City of Portland, Maine – Building or Use Permit Application 389 Congress Street, 04101, Tel: (207) 874-8703, FAX: 874-8716

Location of Construction: 86 Vannah Ave		Owner: Kathleen & Jeffrey Cole		Phone: 772-1013	Permit 950898
Owner Address:		Leasee/Buyer's Name:		Phone:	<div style="border: 2px solid black; padding: 5px; text-align: center;"> PERMIT ISSUED Permit Issued: APR 28 1995 CITY OF PORTLAND </div>
Contractor Name: Kevin Kelly Builder		Address: 202 Washington Ave Ptd, ME 04108		Phone: 773-6285	
Past Use: 1-fam		Proposed Use: Same w/renovations		COST OF WORK: \$ 5,000.00 PERMIT FEE: \$ 45.00 FIRE DEPT. <input type="checkbox"/> Approved <input type="checkbox"/> Denied INSPECTION: Use Group: R3 Type 5B 130CA93 Signature: <i>Holmes</i>	
Proposed Project Description: Raising roof & changing pitch to create living space (bedroom)		PEDESTRIAN ACTIVITIES DISTRICT (P.A.D.) Action: Approved <input type="checkbox"/> Approved with Conditions: <input type="checkbox"/> Denied <input type="checkbox"/> Signature: _____ Date: _____		Zoning Approval: Zone: <i>R-3</i> CBL: 128-C-017 Special Zone or Reviews: <input type="checkbox"/> Shoreland <input type="checkbox"/> Wetland <input type="chec

3rd Floor Plan

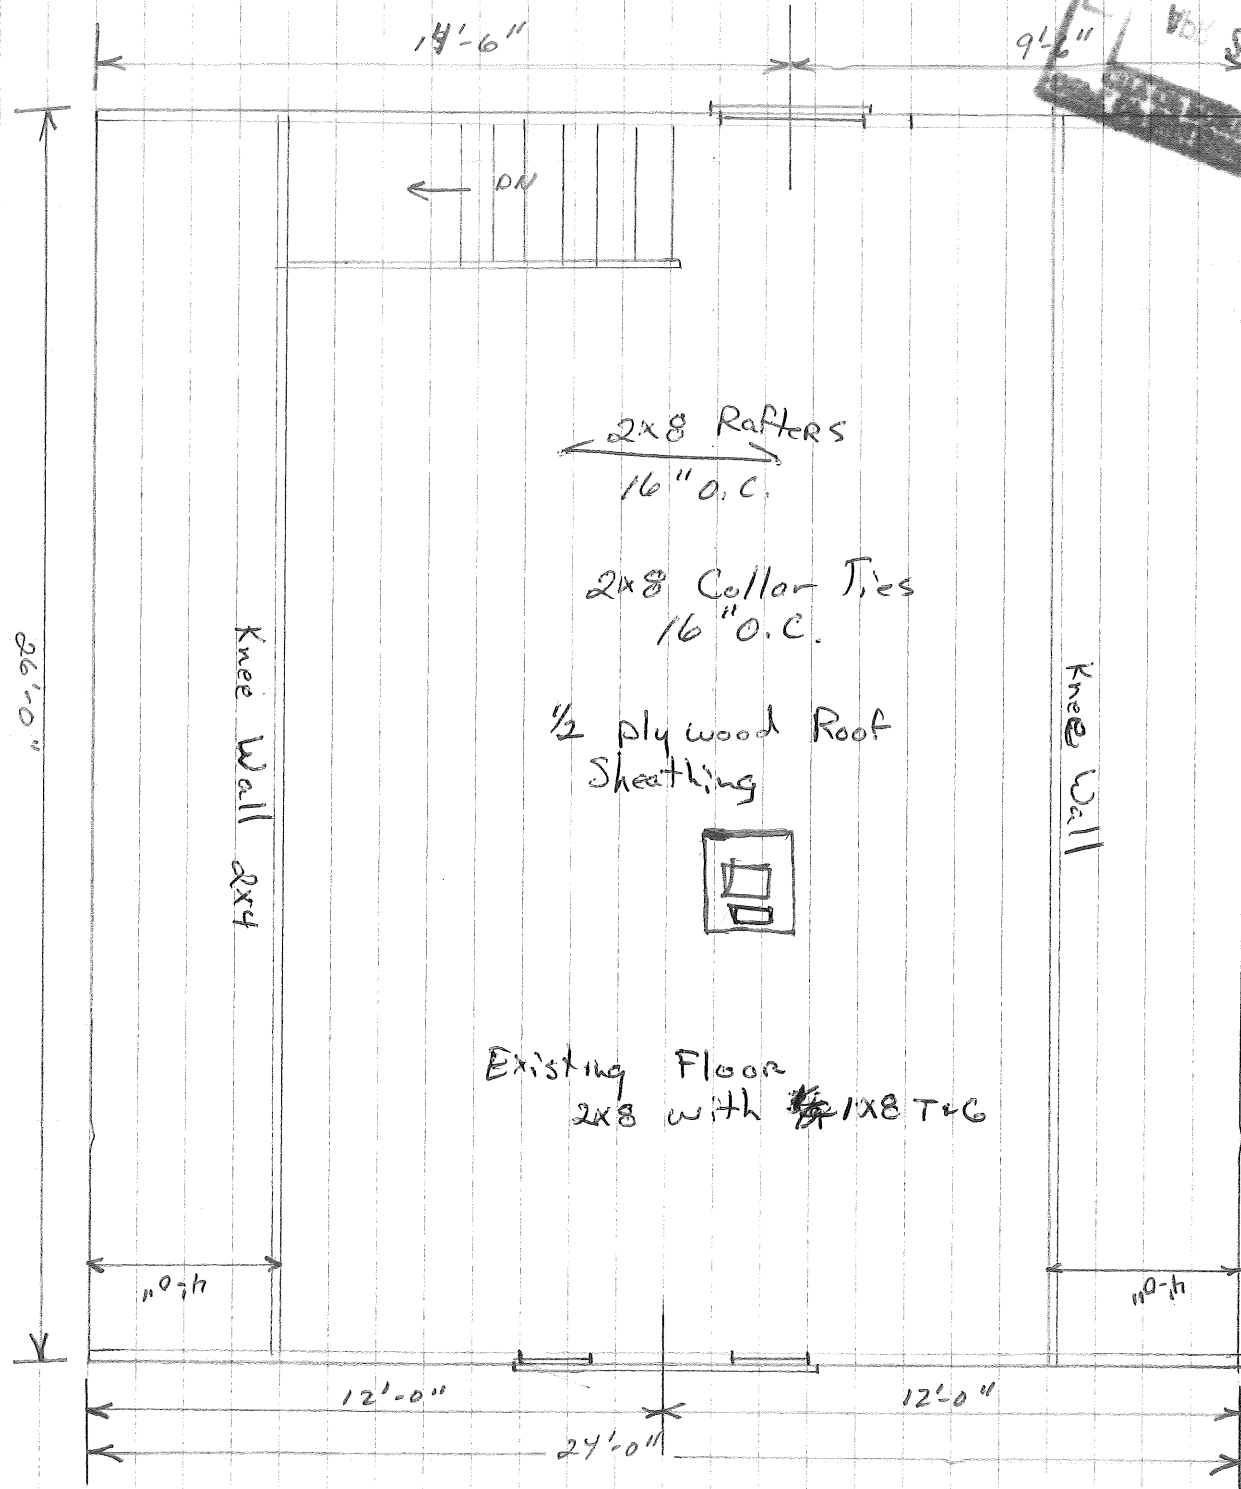
1. This building must remain a single family dwelling.
2. Your submitted plan does not show the size or spacing of the existing floor joist. The floor joist must carry a live load of 40 PSF.
3. Please read and implement items 7, 9, 11, 14, 15 and 16 of the attached building permit report.

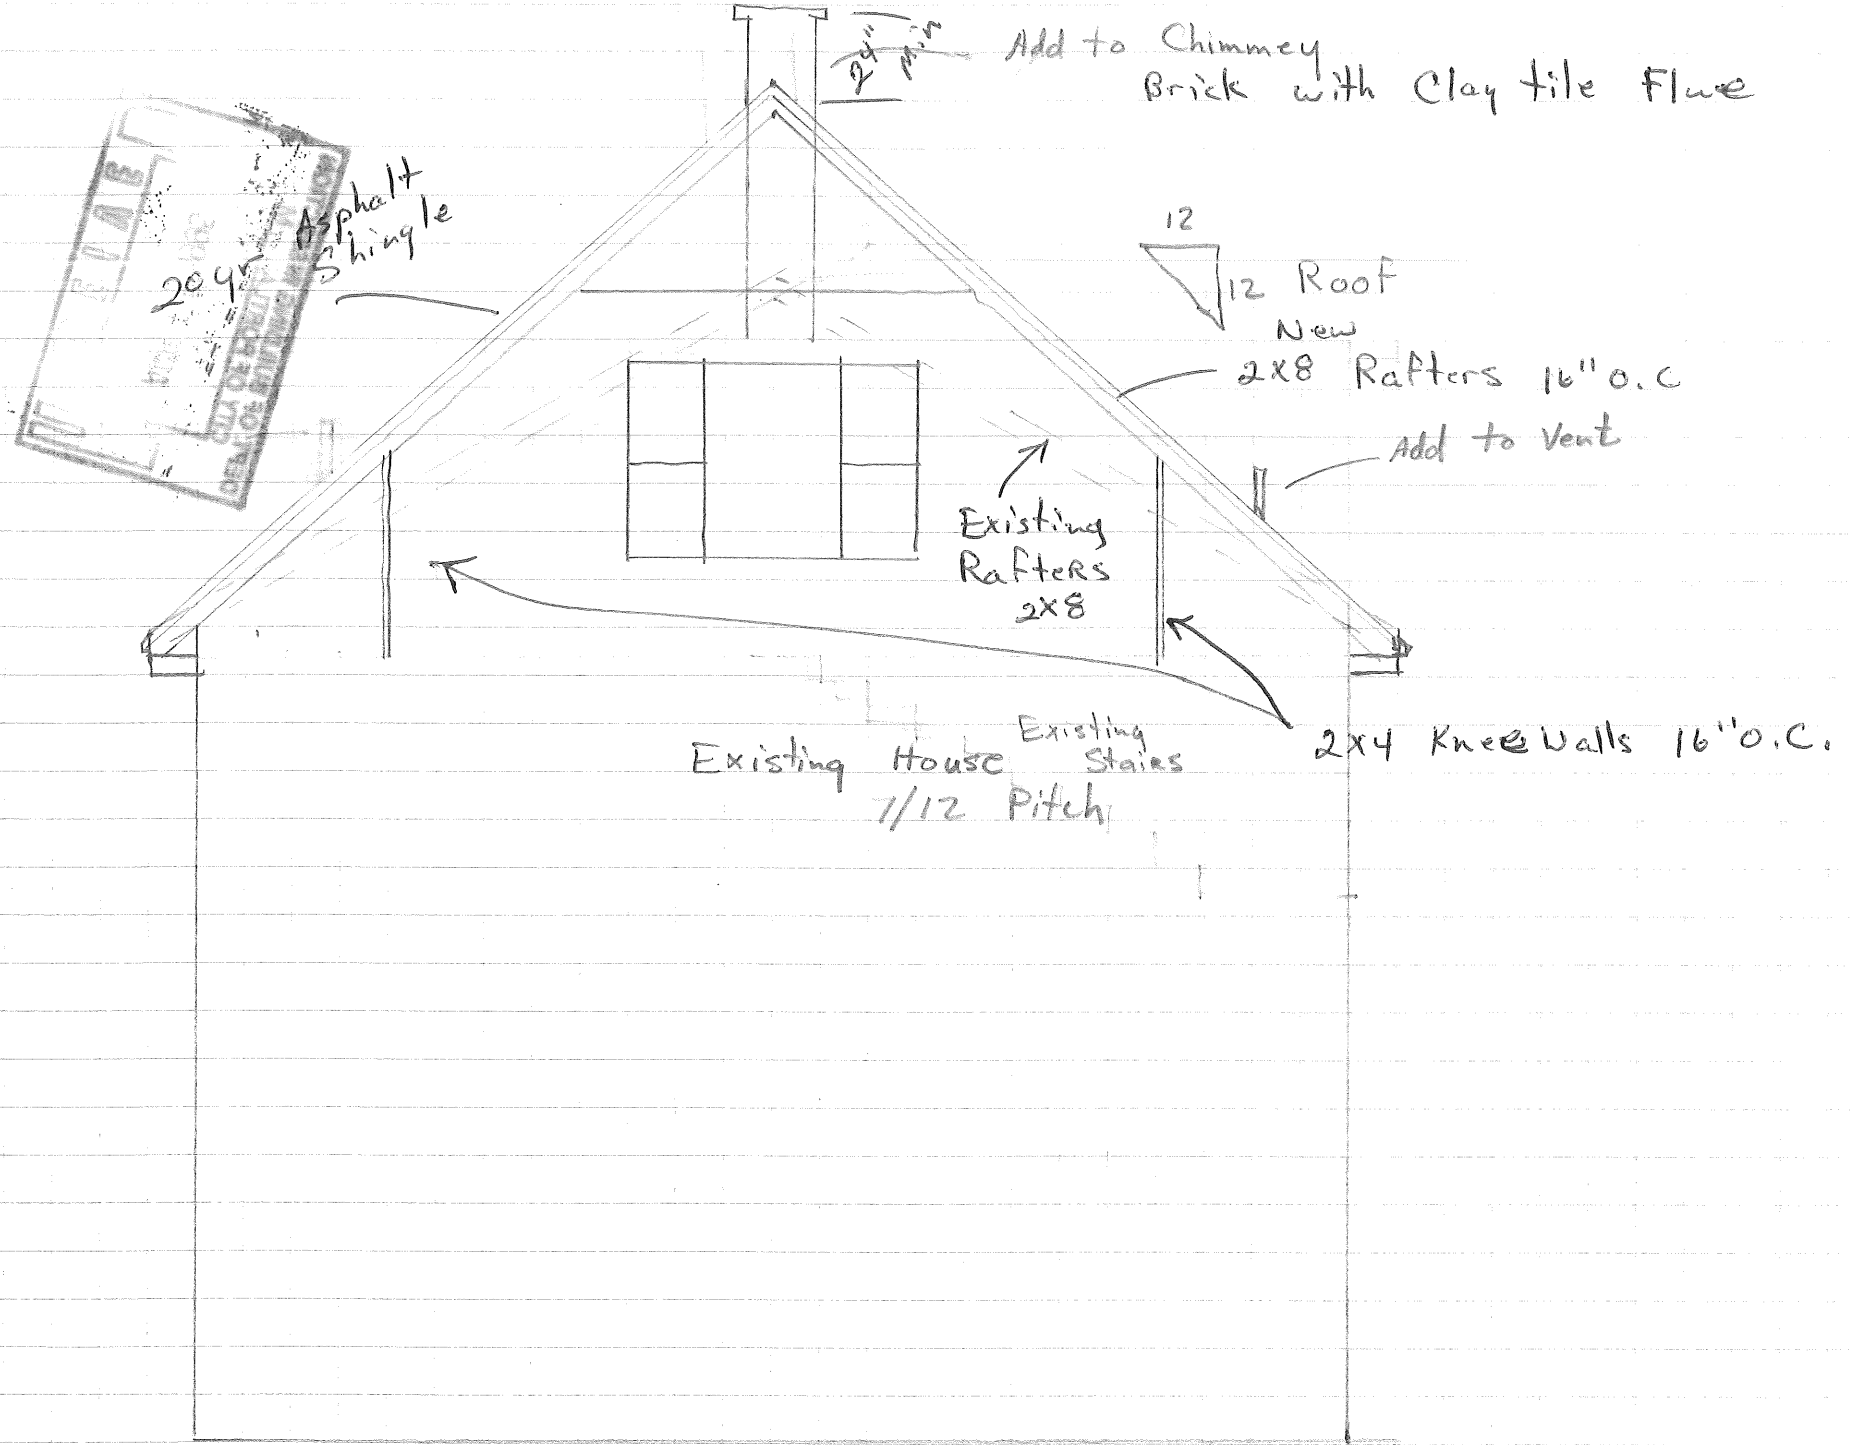
size of rafters and spacing
more sp

framing of Gable window
